Serial No. 10/733,717
Office Action Dated: 05/07/09
Response to Office Action Dated: 11/06/09

AMENDMENTS TO THE DRAWINGS

REMARKS

FIG. 14

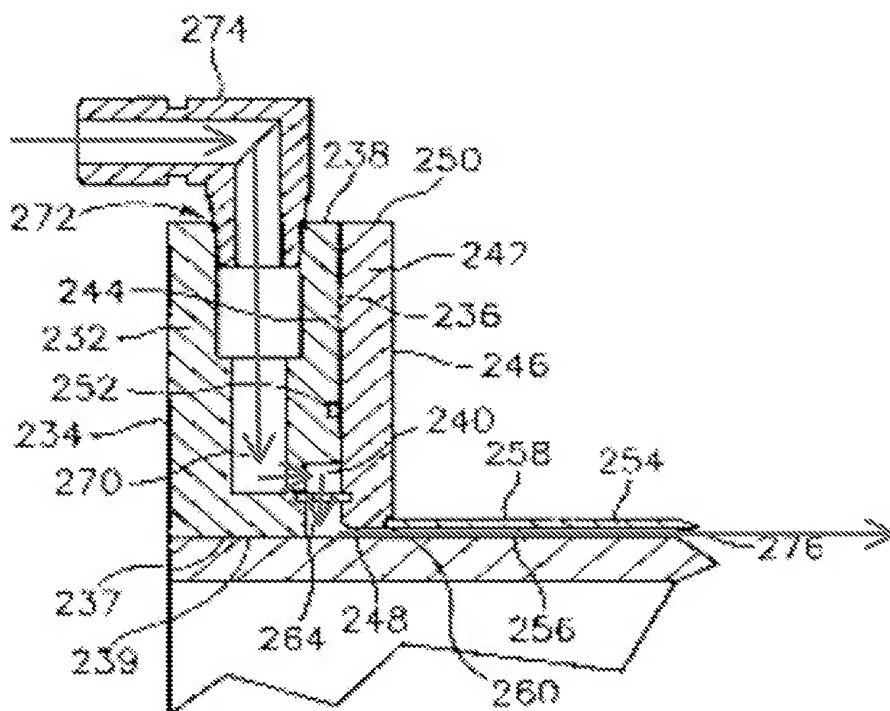
objected to the drawings as failing to show upstream rim 260 in Figure 13;

Additionally, the Examiner asserts that it is not clear from the disclosure of paragraph [0043] how the cooling fluid that enters the flange travels all the way to the cooling gas outlet. Applicant respectfully disagree with the Examiner’s assertion. Specifically, paragraph [0043] of the Specification clearly describes how the cooling flow enters the flange at ports 272 through fittings 274. The cooling flow then proceeds through passageways 270 and metering ring 264 into the annular space 276, to be discharged from the cooling gas outlet 278. (Specification, paragraph [0043]). This cooling flow path is clearly seen in Figures 13 and 14, as illustrated below in amended Figure 14.

Furthermore, Applicant respectfully submits that the bolts do not need to be shown in Figures 13 and 14, as asserted by the Examiner. (See Office Action, page 4). As the Examiner notes in the Office Action, Figure 13 is a sectional view of Figure 12. Figure 14 is an enlarged view of a portion of Figure 13. It is clear from Figure 12 that neither the bolts nor the bolt holes are in the section through which Figure 13 is taken. In fact, the bolts are not even shown in Figure 12. Therefore, the bolts should also not be shown in Figure 13.

Please replace Sheets 9/10 and 10/10, including Figures 13-15, with the enclosed Replacement Sheets 9/10 and 10/10, including Figures 13-15.

Regarding the objections to the Drawings, Applicant respectfully submits that the current amendments to the claims, Specification and Drawings fully address the objections. Specifically, the first and second faces of claim 1 have been amended to recite “upstream and downstream faces” which are shown in at least amended Figure 14. Additionally, paragraph [0043] of the Specification has been amended to include a central aperture 239, which is shown in at least amended Figures 13 and 14. Claim 1 has been amended to replace “inboard surface” with “interior surface,” which is shown in at least amended Figure 14.

Additionally, Figure 13 has been amended to include the “upstream rim 260.” Accordingly, Applicant respectfully requests that the objections to the Drawings be withdrawn.

Regarding the rejection of claims 1-5 under 35 U.S.C. §112, first paragraph, as failing to comply with the enablement requirement, Applicant respectfully submits that the “central aperture” is described in at least amended paragraph [0043] of the Specification and shown in at least Figures 13 and 14. Additionally, Applicant respectfully submits that the “first and second faces” have been amended to recite “upstream and downstream faces,” which are described in at least amended paragraph [0043] of the Specification and shown in at least Figure 14 of the Drawings.
